Palisades Nuclear Plant  
Operated by Nuclear Management Company, LLC

Nuclear Management Company Response to Request for Additional Information RE:  
Relief Requests for Reactor Vessel Head Penetrations at the Palisades Nuclear Plant

**ENCLOSURE 1**  
**NUCLEAR MANAGEMENT COMPANY RESPONSE TO REQUEST FOR**  
**ADDITIONAL INFORMATION RE: RELIEF REQUESTS FOR REACTOR VESSEL**  
**HEAD PENETRATIONS AT THE PALISADES NUCLEAR PLANT**

### FIGURES OF NOZZLE CONFIGURATION DURING REPAIR PROCESS

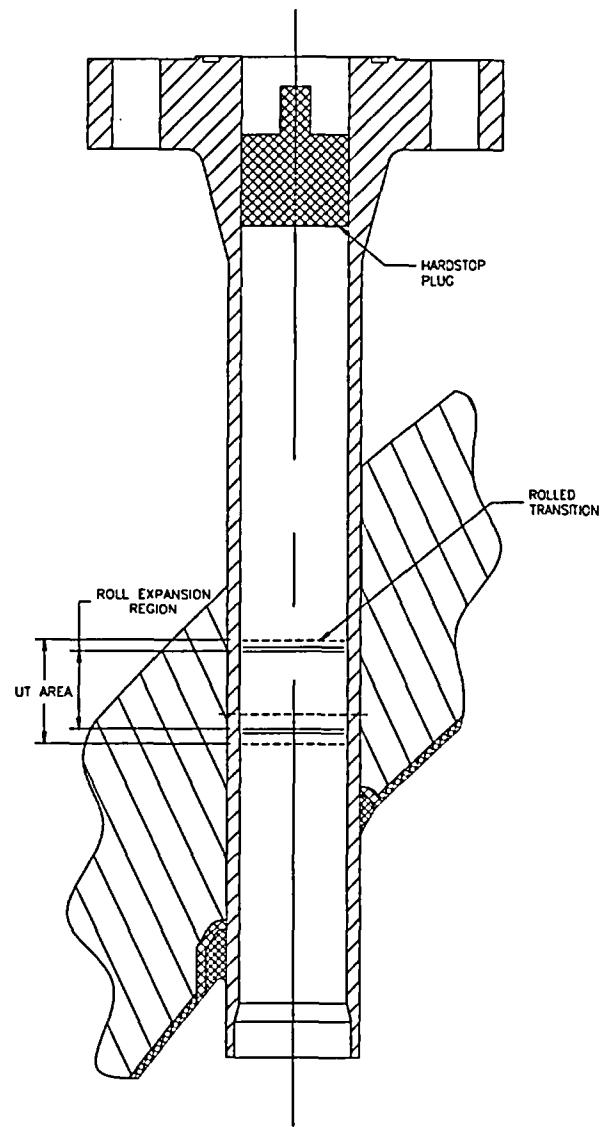
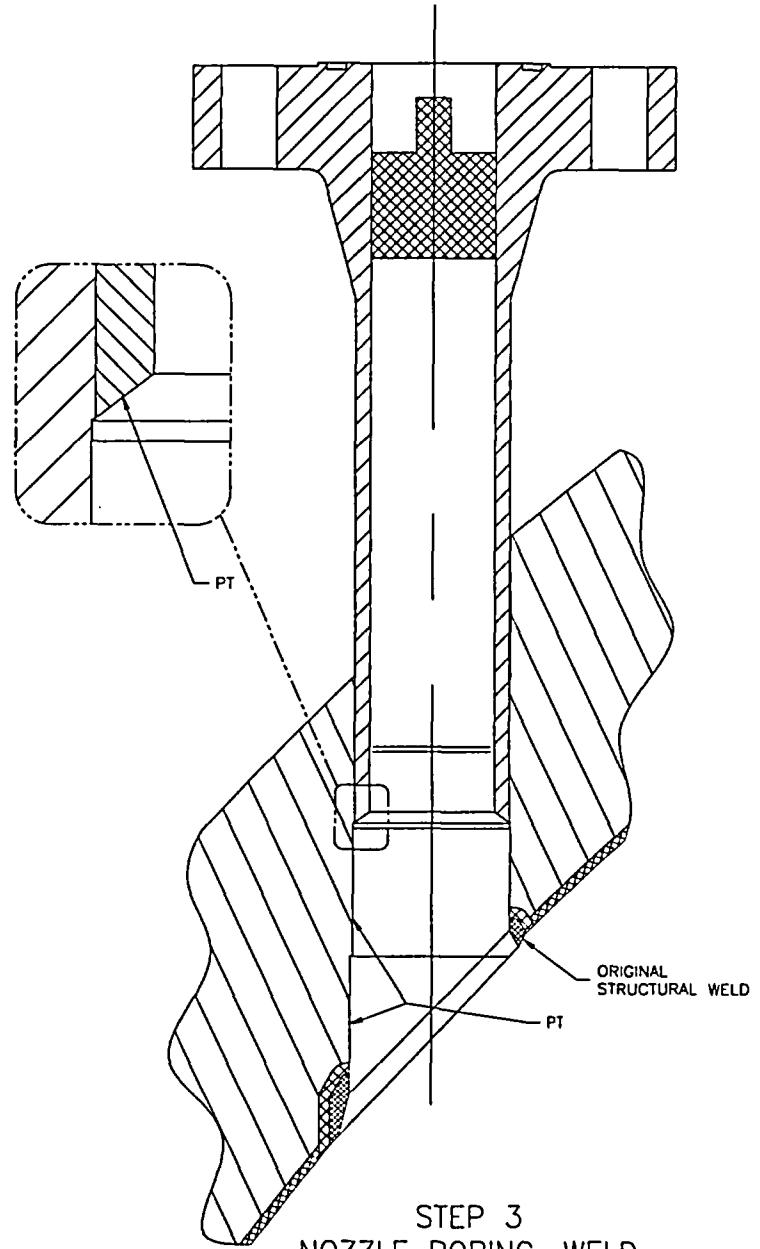
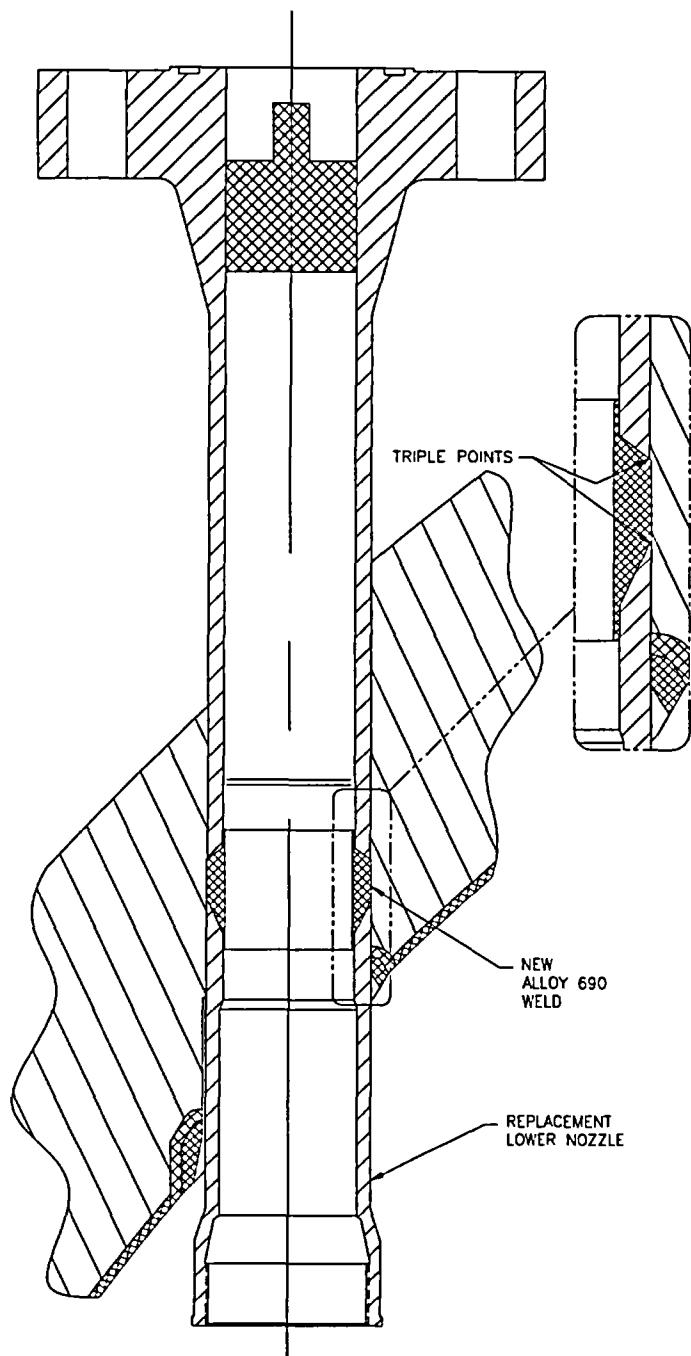
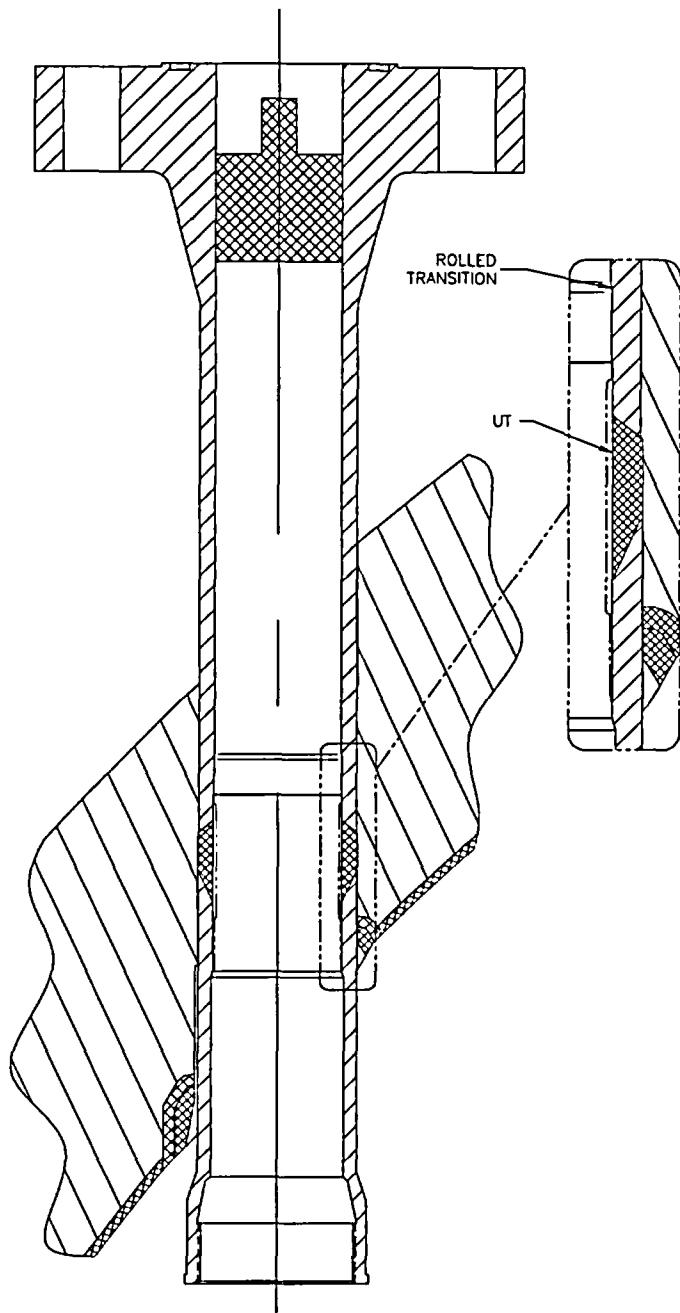
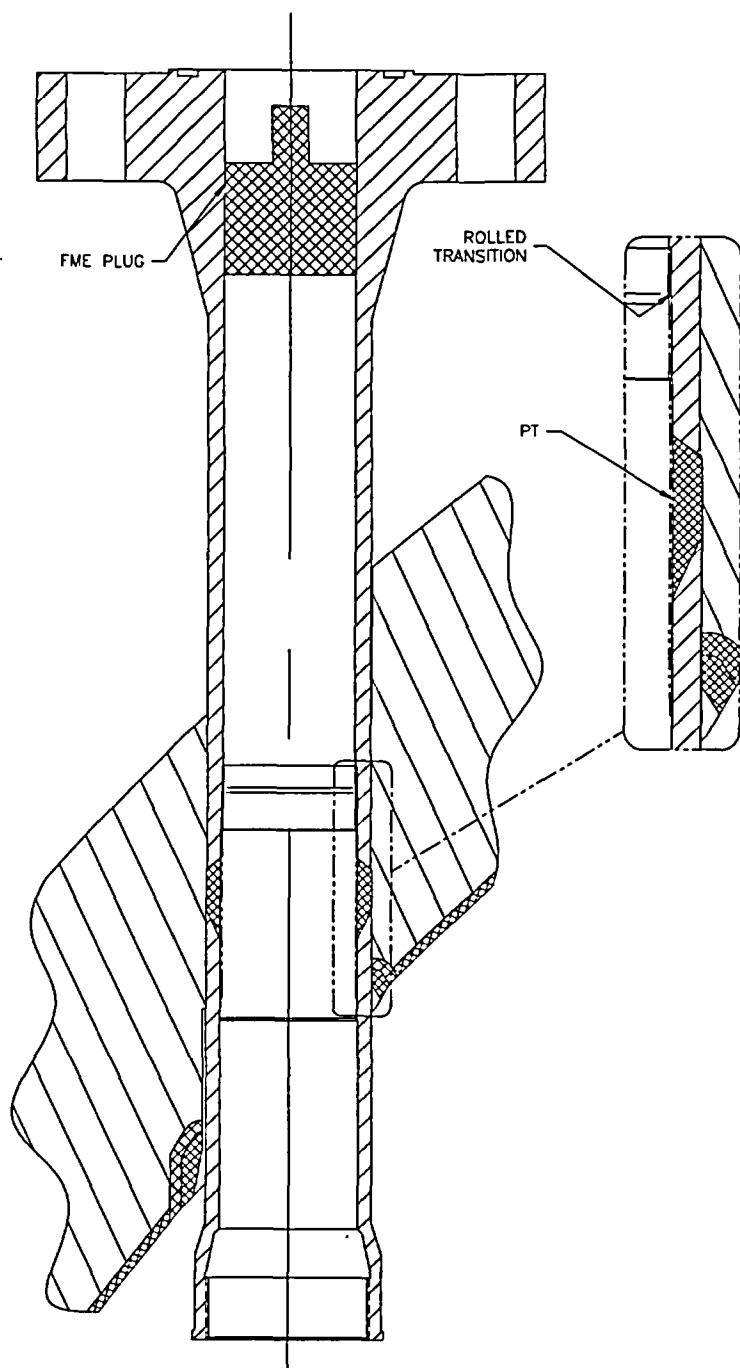
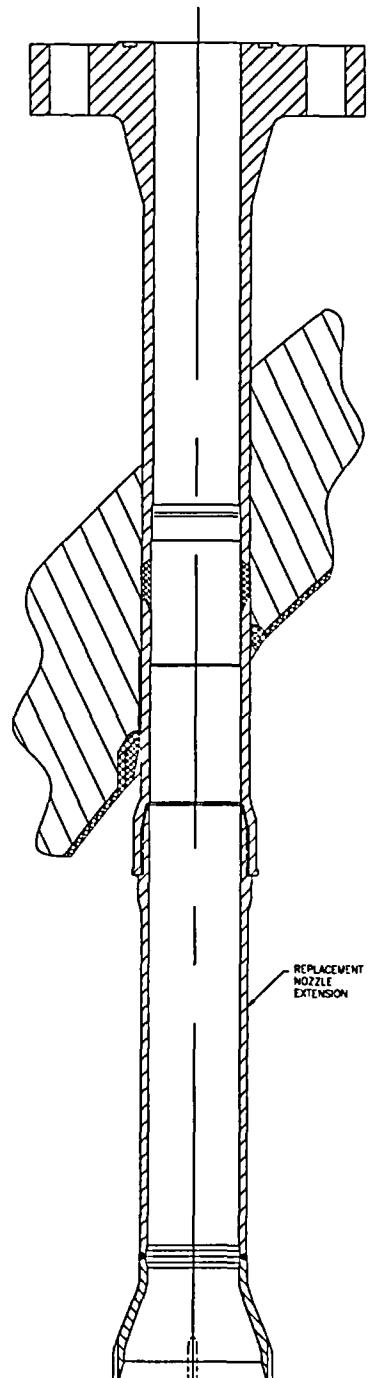
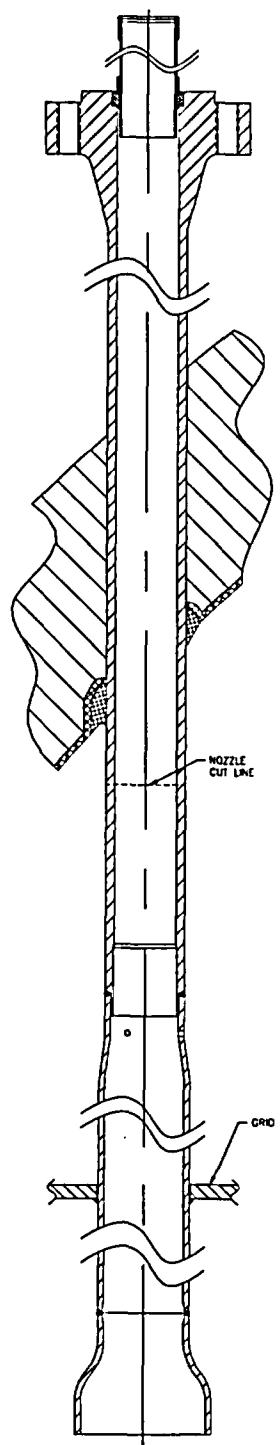
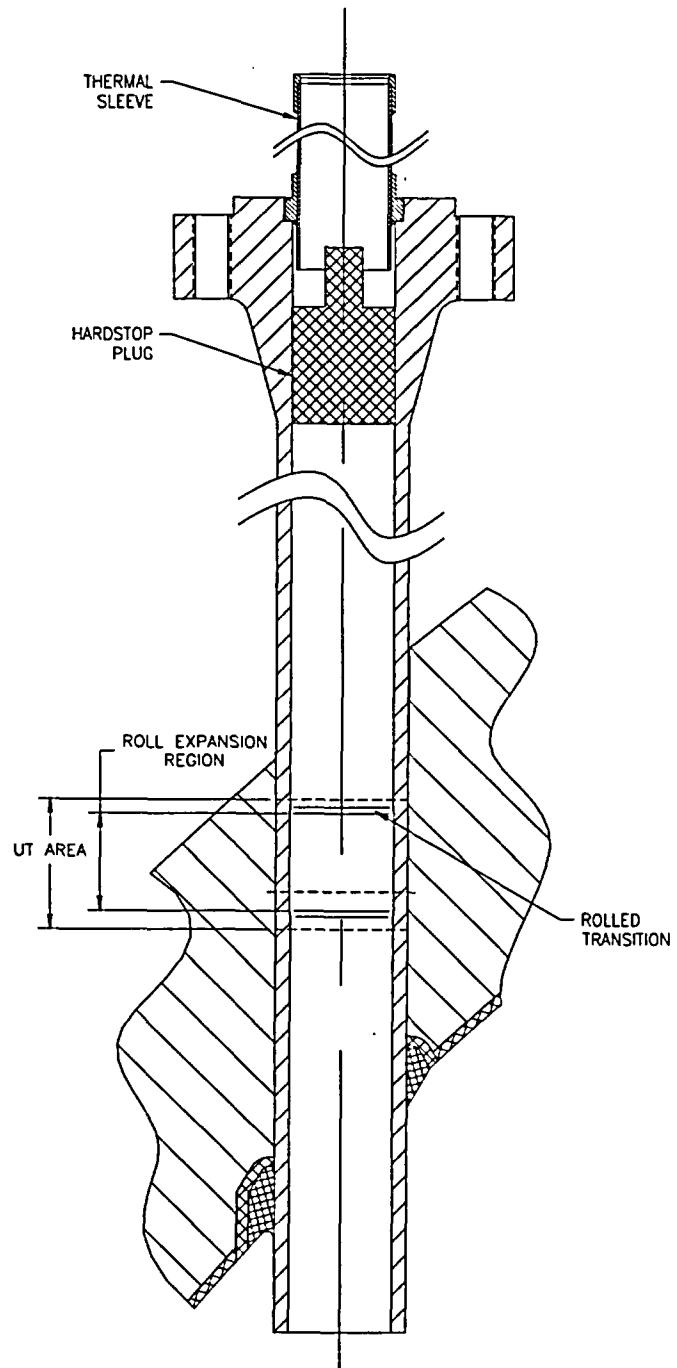
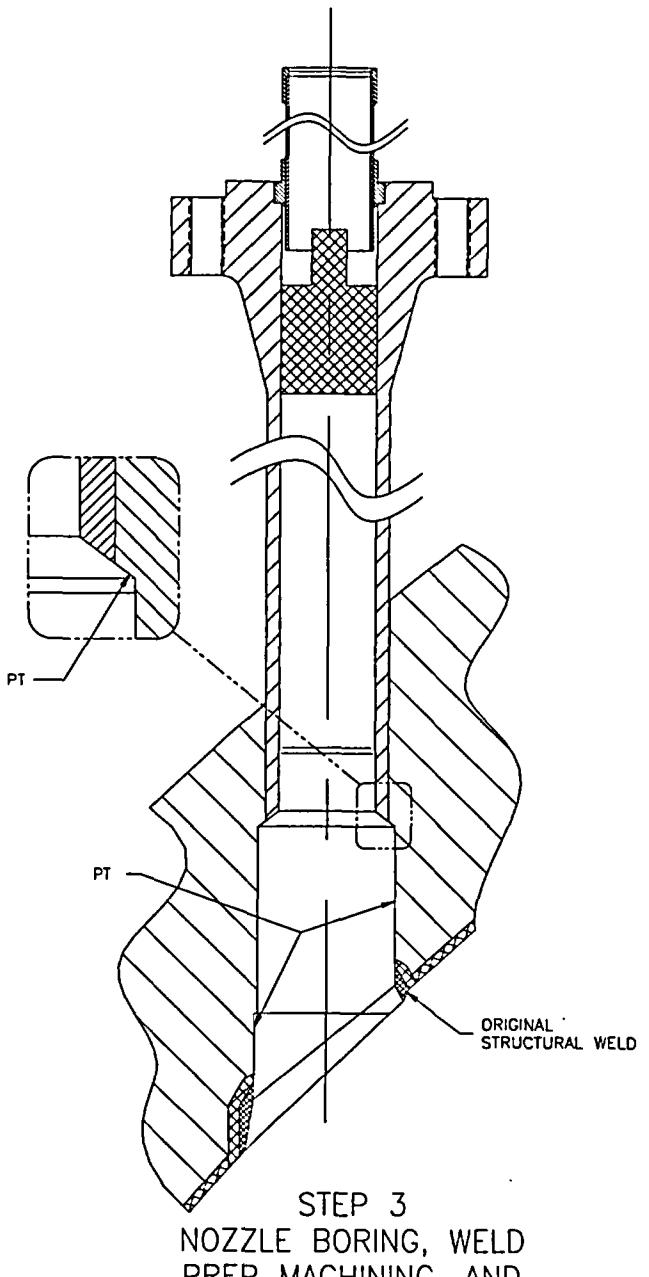
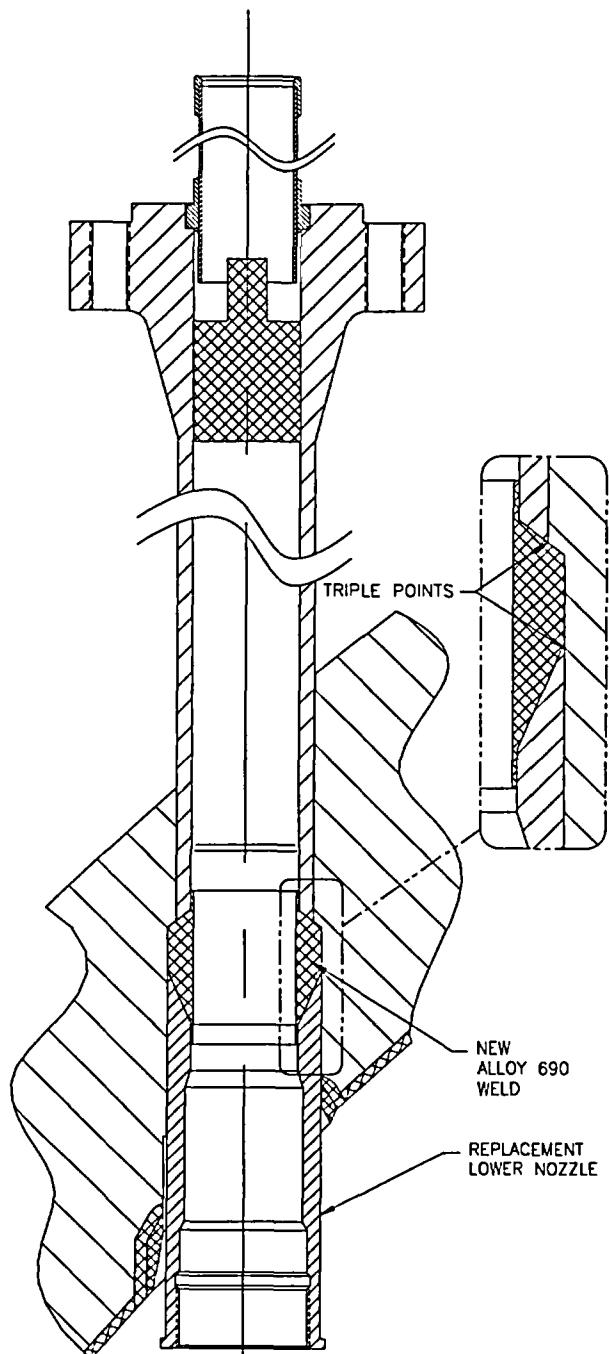
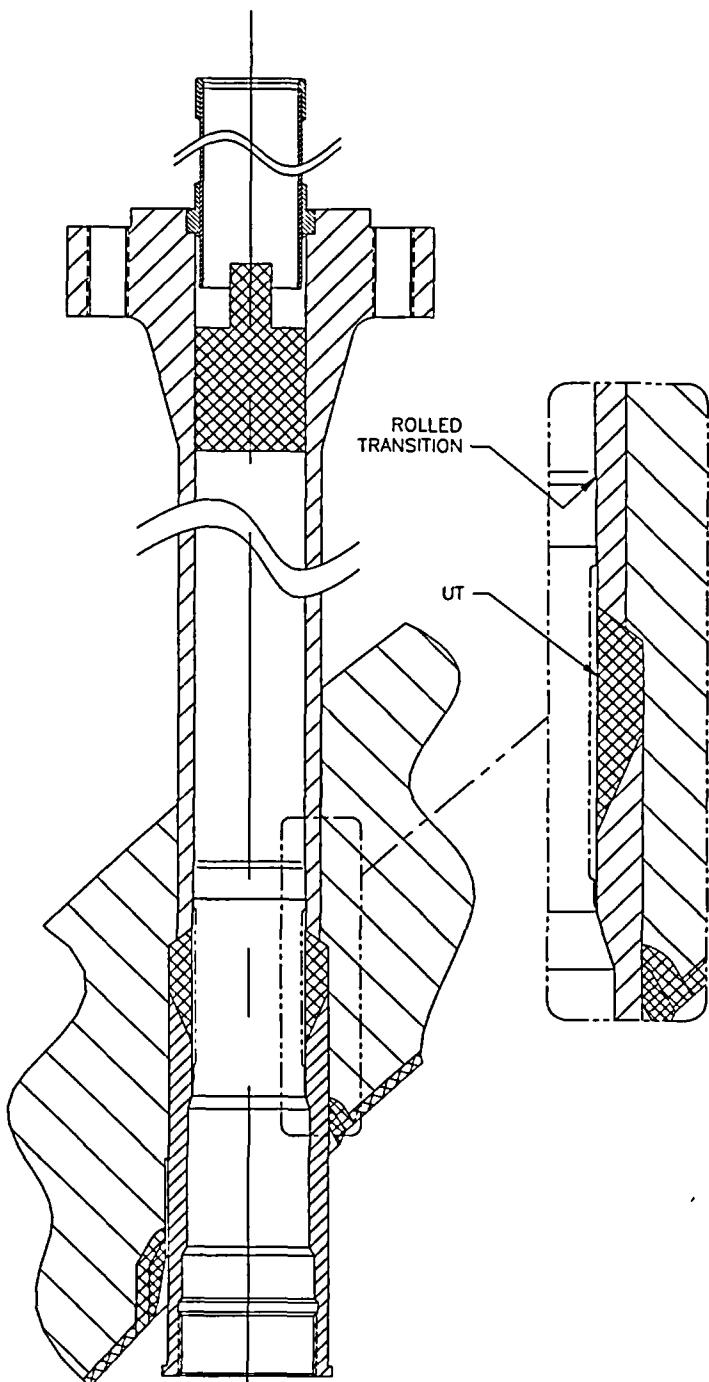
1. *The reactor vessel head penetration repair is described briefly on page 4 of AREVA document 32-5043862 in Attachment 2 to Relief Request #1. The staff needs detailed description. (1) Submit a document (or reference a document that has been submitted previously) that describes the repair plan, or discuss in detail step-by-step repair of the control rod drive (CRD) nozzle and incore instrumentation (ICI) nozzle. (2) The discussion should include physical dimensions of the components such as wall thickness, diameter, length of the CRD and ICI nozzles, and thickness of the repair weld. (3) Discuss how the lower portion of the nozzle is removed from the closure head bore and detached from the J-groove weld. (4) Discuss whether removal of the nozzle will cause crack initiation in the J-groove weld. (5) Discuss why the inside of the replacement nozzle is divided into several segments with various inside diameters and wall thickness. (6) Discuss whether various inside diameters in the replacement nozzle will cause lateral movement of the control drive mechanism shaft. (7) Discuss whether the metal surfaces (base metal and original nozzle) are cleaned before the repair weld is made.*

1. (1) A detailed process outline of the control rod drive mechanism (CRDM) and in-core instrumentation (ICI) nozzle repair is described below. Provided in Attachment 1 are figures that show the nozzle configuration during the process. The repair process is the same for the CRDM and ICI nozzles, except as noted in the process outline.
  - a. Ultrasonic (UT) the weld repair area.
  - b. Cut tube grid structure adjoining the target nozzle and surrounding CRDMs. (CRDM only)
  - c. Cut the nozzle and remove the nozzle extension close to the underside of the head.
  - d. Roll expand nozzle body.
  - e. Clean the bore.
  - f. Bore the lower nozzle OD slightly oversize up to the location of the repair weld. The lower portion of the remaining nozzle is beveled suitable for welding.

(5) The replacement nozzle ID contains 3 different diameters. In the installed orientation, the upper ID matches the ID of the original CRDM/ICI nozzle. The middle ID is slightly larger than the upper ID so that the time required to final machine the new weld is minimized (total length of the replacement lower nozzle machined is limited to length of upper ID). The lower ID is slightly larger than the middle ID so that the replacement nozzle extension can "nest" inside the replacement nozzle, thereby creating a smooth transition. (See step 7 of the attached CRDM repair figures provided in Attachment 1).
